**DOCUMENT 00 91 04
ADDENDUM NO. 4**

PROJECT: 2024 Cy Lakes HS Renovation
BID DATE: **Thursday, December 19, 2024 (no Change)**
FROM: Carolina Weitzman, A.I.A.
Natex Corporation Architects
447 Heights Blvd, Houston, TX 77007
TO: **Prospective Bidders**

**2024 CY-LAKES HIGH SCHOOL
RENOVATION**
5750 GREENHOUSE RD., KATY, TX 77449
CFISD PROJECT NO. 24-02-5749-R-RFP

AV3.00

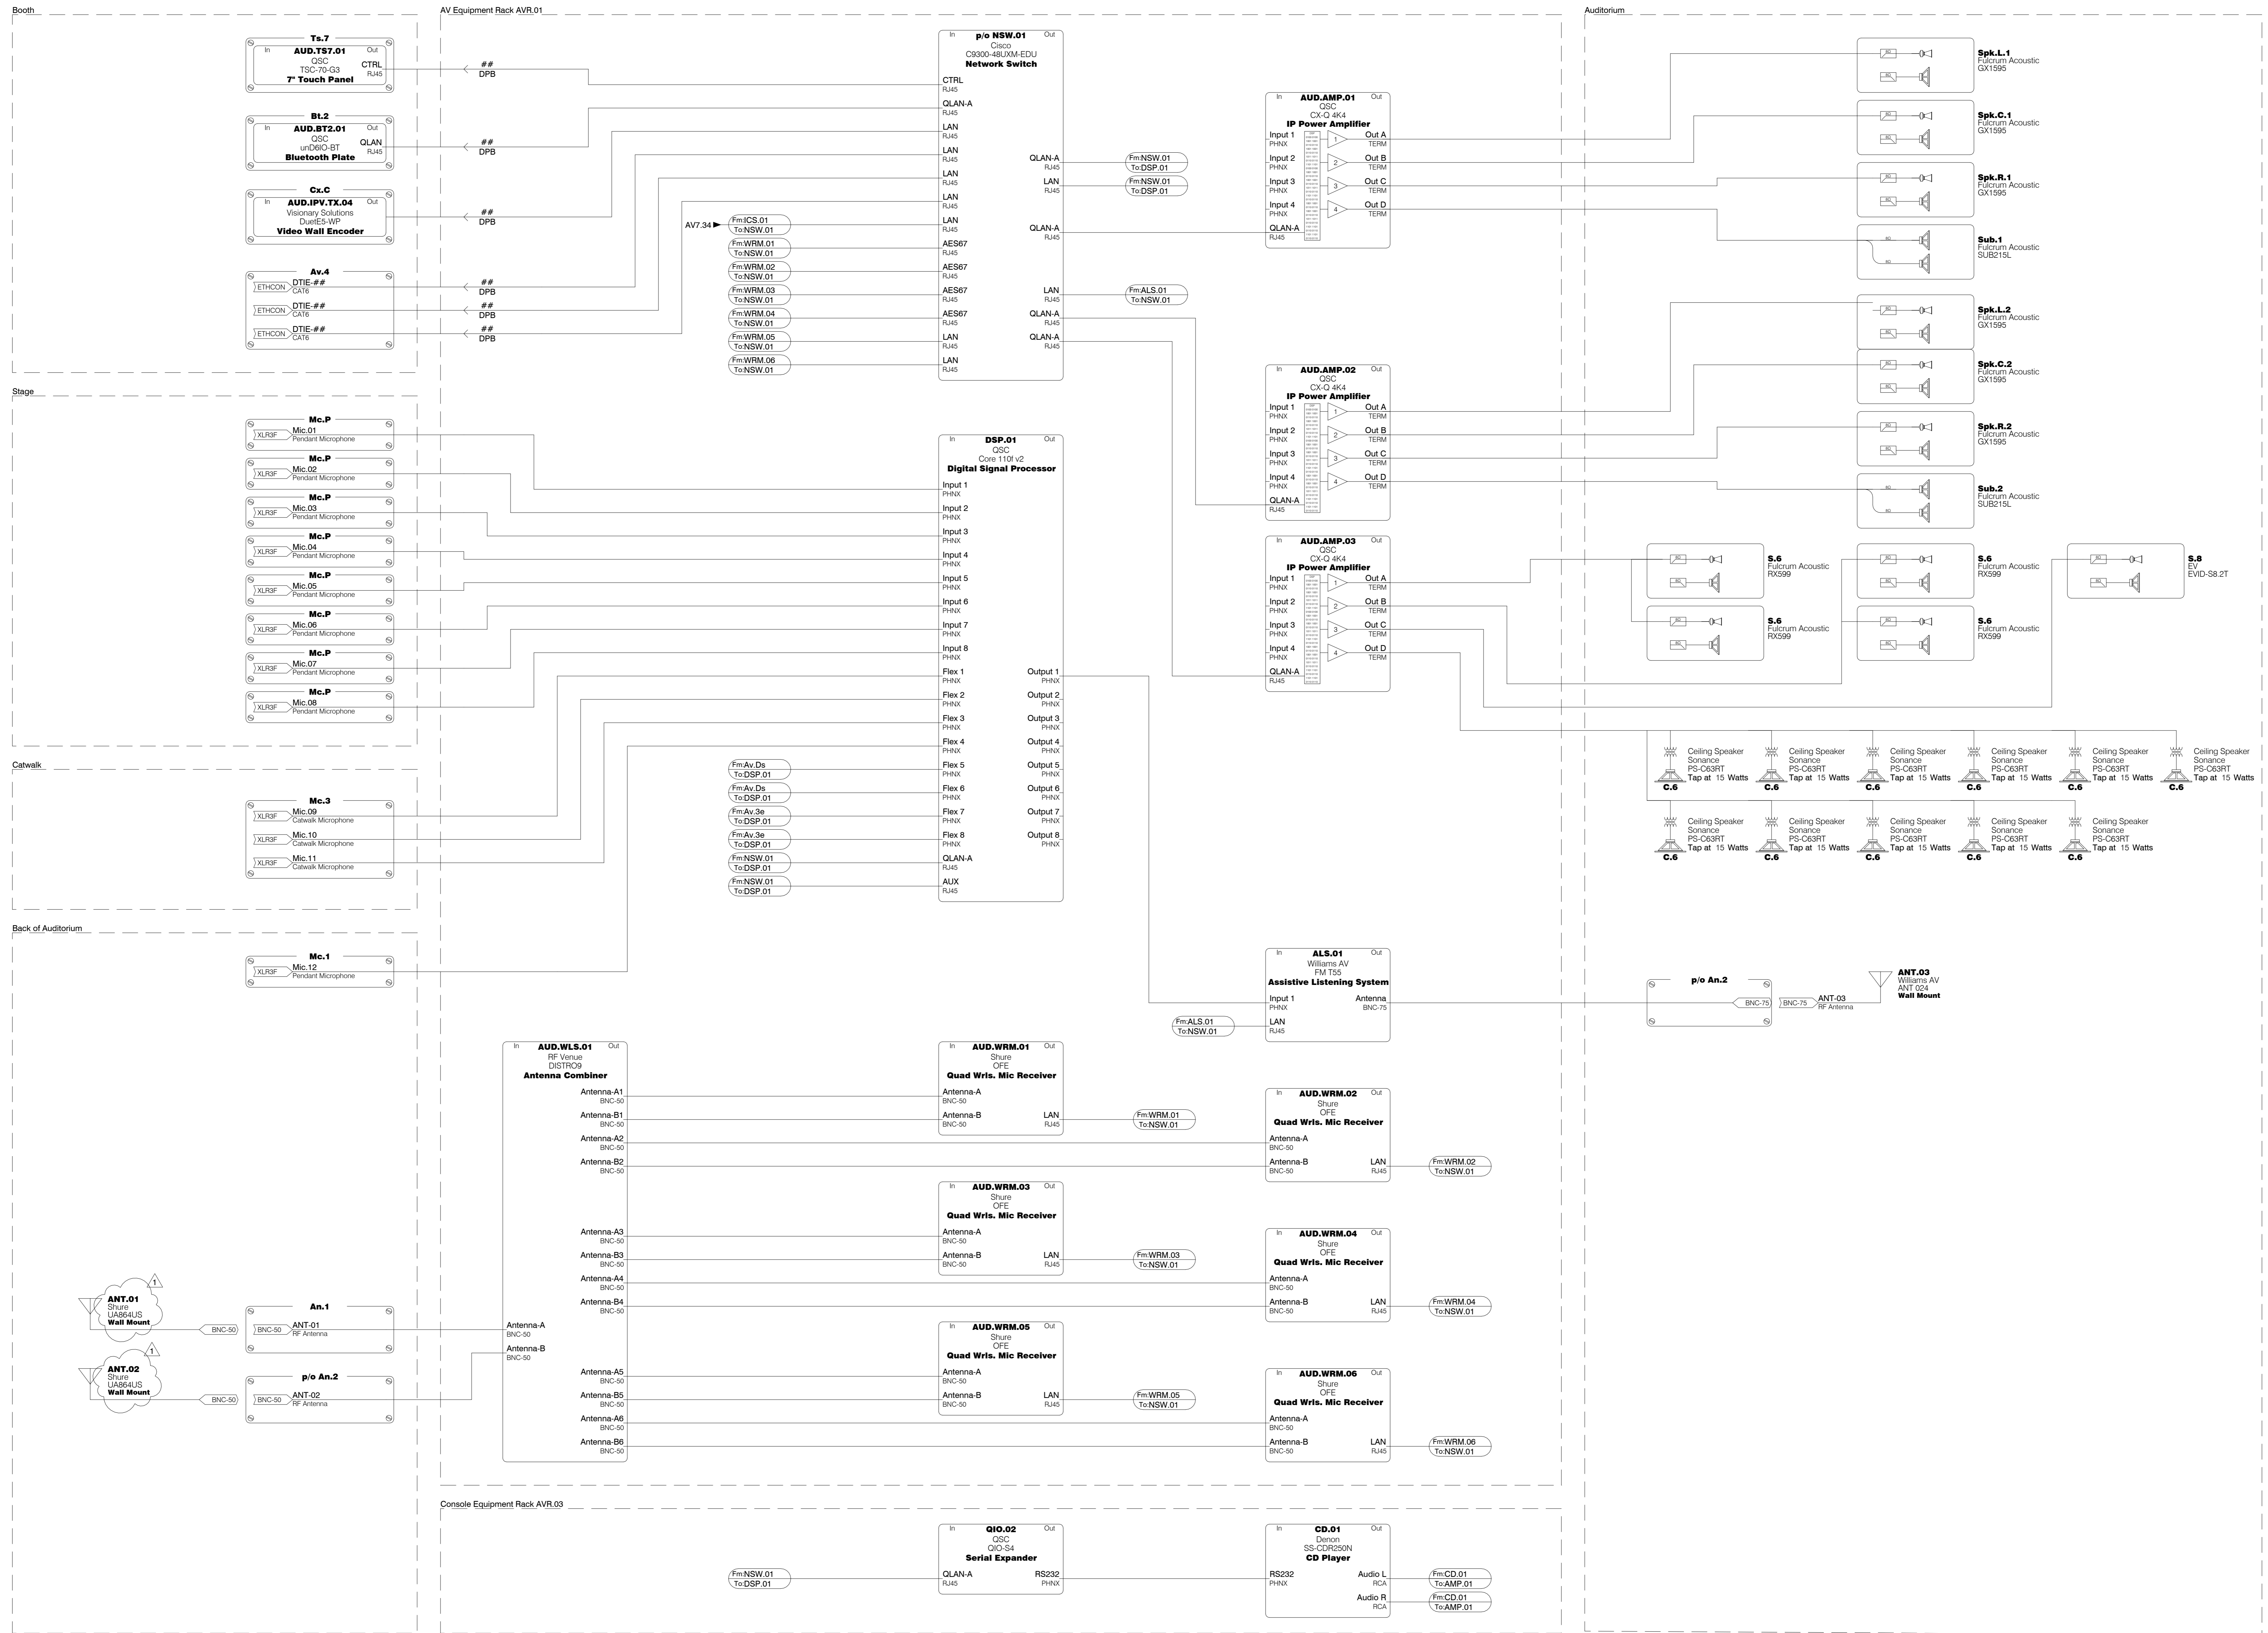
1. SHEET T0.00, "TECHNOLOGY LEGENDS AND SCHEDULES":
 - a. Remove reference to 27 41 16.10 Specification in Audio Video Legend
2. SHEET P5.02, "PLUMBING ENLARGED FLOOR PLAN":
 - a. Revise SK-6 TO SK-5. Greenhouse sink will be same as SK-5
3. AV3.00 – AV – SECTIONS & ELEVATIONS - AUDITORIUM
 - a. Clarified stage lip wall plate elevations.
 - b. Refer to revised sheet
4. AV7.30 – AV SCHEMATICS
 - a. Change wireless antenna to Shure UA864US
 - b. Refer to revised sheet

AV7.30

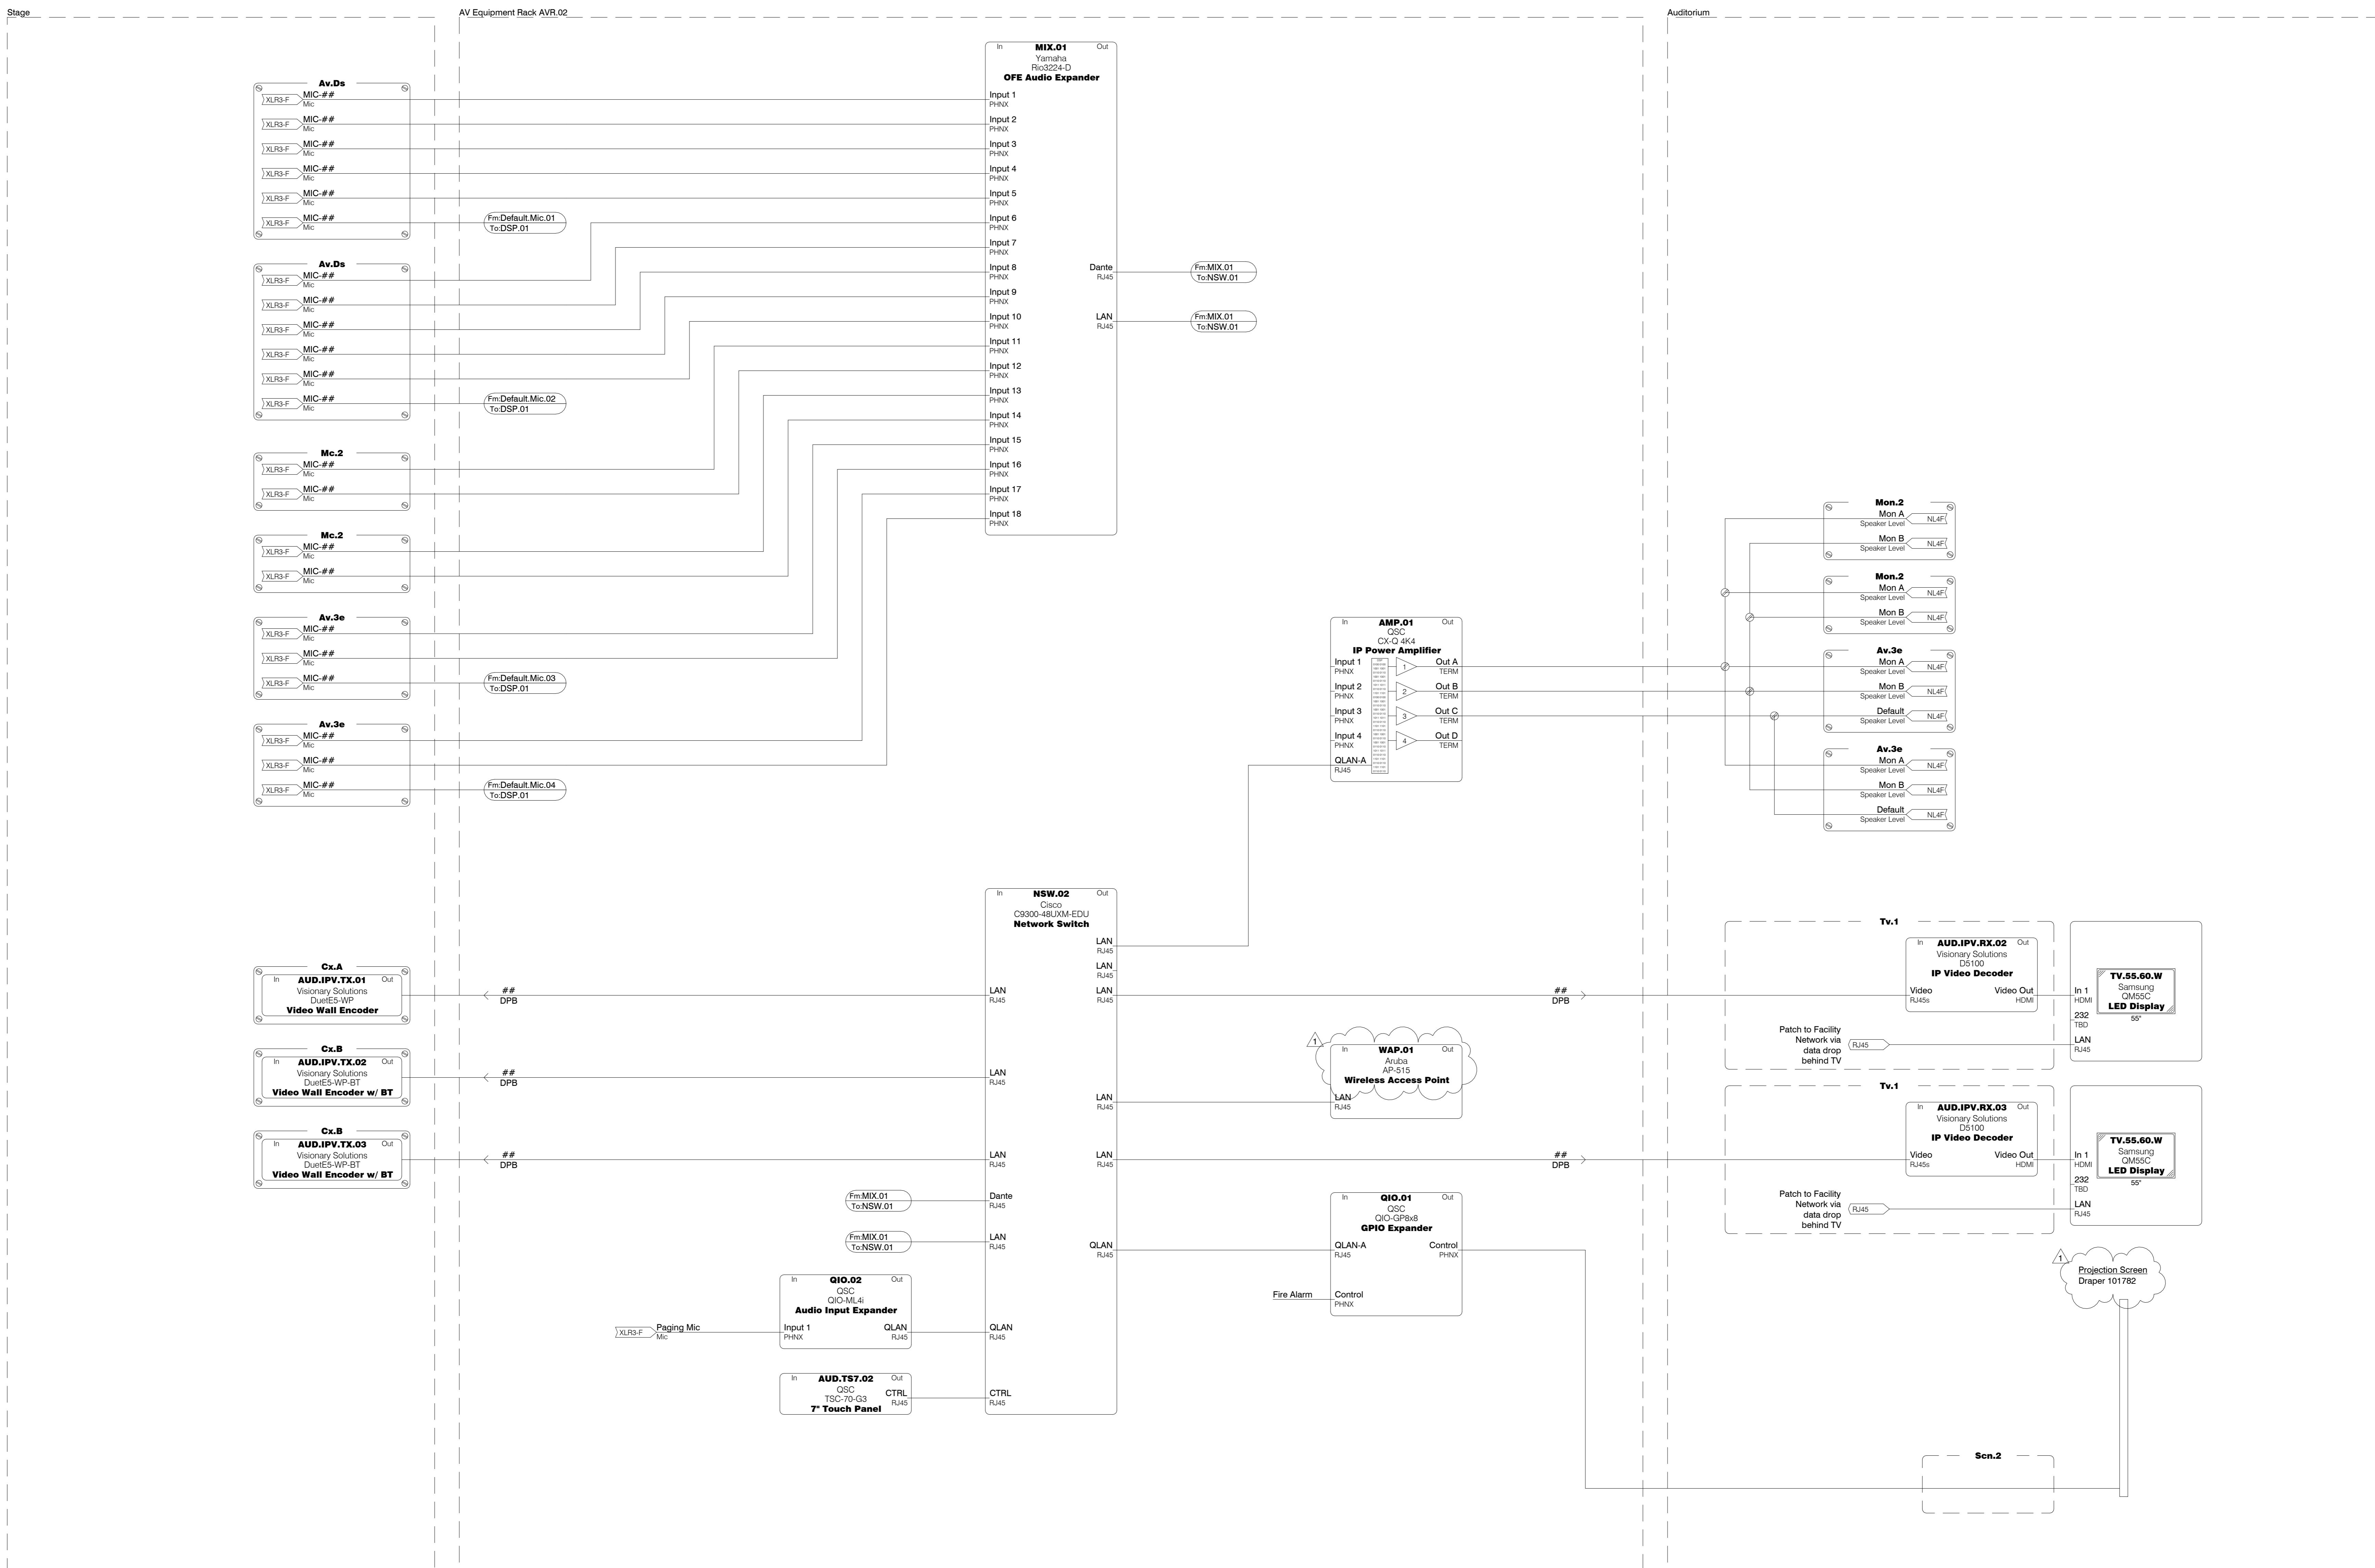
1. **Question:** Catwalk Microphone - AV series drawing AV7.30 details a (3) catwalk microphones being installed into the auditorium. Specification Section 274134 does not detail nor quantify a catwalk microphone make and model. Please indicate a desired manufacturer and model of microphone to be used for the catwalk.
Answer: See pg 32 of the 27 41 34 spec - the (2) AKG C451 B and (1) Audix M1255B.

2. **Question:** Auditorium Wireless Antenna - AV series drawing AV7.30 details a Sennheiser ADP UHF antenna being installed in the auditorium for the wireless mic system. Specification Section 274134-32 details a Shure UA864US antenna for the auditorium wireless mics system. Please confirm which antenna is to be used for the auditorium.
Answer: Updated in Add. 4. Use the Shure UA864US.
